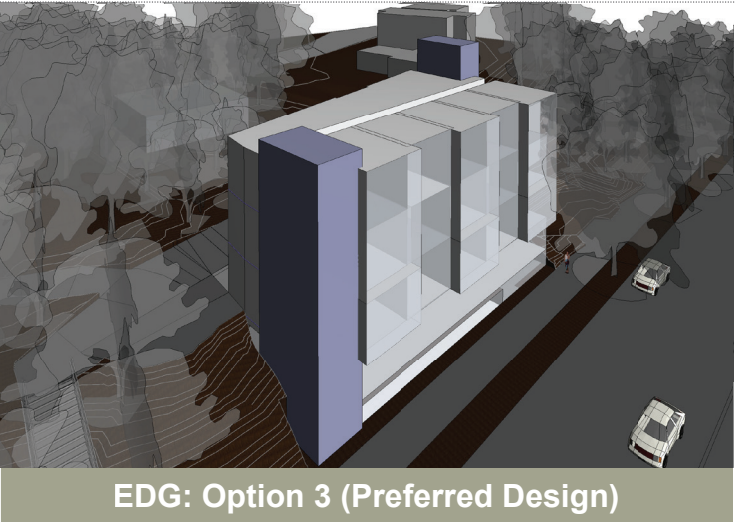
b. The conceptual floor layout plans and landscape drawings for Option 3 in the EDG design packet (pgs. 25-26 and 29) illustrate ground-level indoor amenity space, landscaped ground-level outdoor amenity and screened private exterior amenity space at alley level. Staff is concerned about the safety, design and location of the exterior amenity spaces which appear to be narrow in width, angled, and not conducive to social interaction. Staff expects the open space concept and programing be clarified and its programing demonstrated in the design at MUP review. (DC3.A, DC3.B, DC4.D)

*THE AMENITY AREA ON THE ALLEY LEVEL ARE PRIVATE AMENITIES BELONGING TO INDIVIDUAL UNITS. THESE AREAS ARE SCREENED BY FENCING AND ARE ADEQUATELY LIT FOR THE USE OF THE TENANTS.*

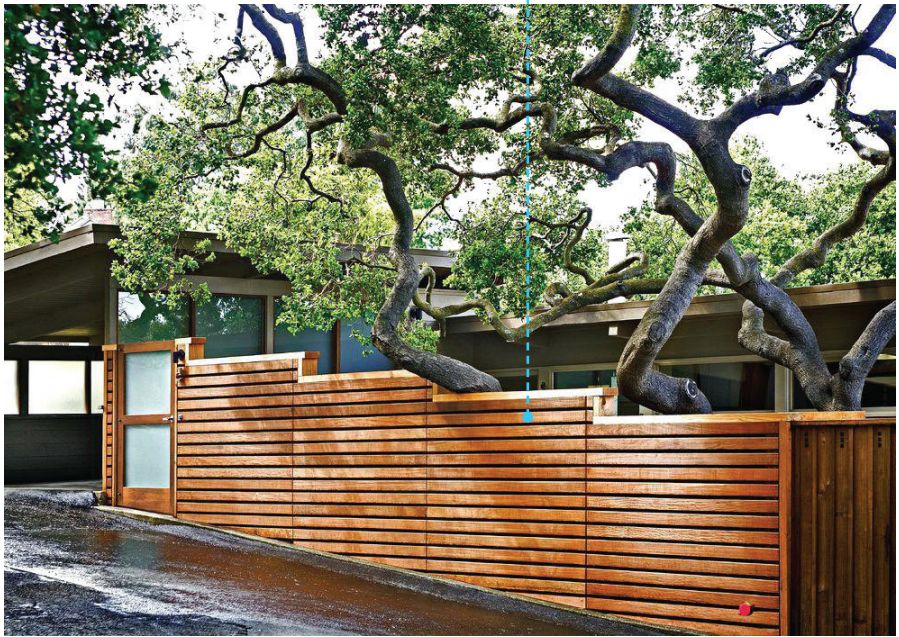
c. Staff is pleased that the waste storage space is planned to be located onsite and be accessible by waste providers from the alley. Staff requests that specifics concerning waste storage, location, access, screening, staging and feedback from SDCI and Seattle Public Utilities (SPU) be provided during the MUP review phase. (DC1.B.1, DC1.C.4)

*THE DEPARTURE FOR THE TRASH AREA AND ITS ACCESS FOR THE TRASH COLLECTION HAS BEEN APPROVED BY ANGELA WALLIS AT SEATTLE PUBLIC UTILITIES AND THE DETAILS HAVE BEEN PROVIDED IN THIS PACKET AND THE MUP SUBMITTAL.*

CODE SECTION	Table A 23.45.040
CODE REQUIREMENT	375 SF Shared Storage for Solid Waste for 26-50 Residential Dwelling Units
PROPOSED DESIGN DEPARTURE	225 SF Shared Storage for Solid Waste for 26 SEDU units
REASONING FOR DEPARTURE	<p>Table A 23.54.040 requires 225 SF Trash area for 16-25 Dwelling Units &amp; 375 SF Trash area for 26-50 Dwelling Units for a Residential Development.</p> <p>This project has 26 Small Efficiency Dwelling Units (SEDU) which produces less solid waste impact than a typical Multi-family dwelling unit.</p> <p>The project is provided with adequate Trash/Recycle/Compost Dumpsters as required for 26 Units by SPU in the 226 SF designated trash area. There is 4'-8 1/2" feet of clearance between the edge of the dumpster and the entry space, and a total of 7'-9" clearance to maneuver the dumpsters in and out of the trash area.</p> <p>Therefore, we request for a Departure to be allowed to use the 225 SF Shared Storage for Solid waste for the 26 SEDU units for this project.</p>
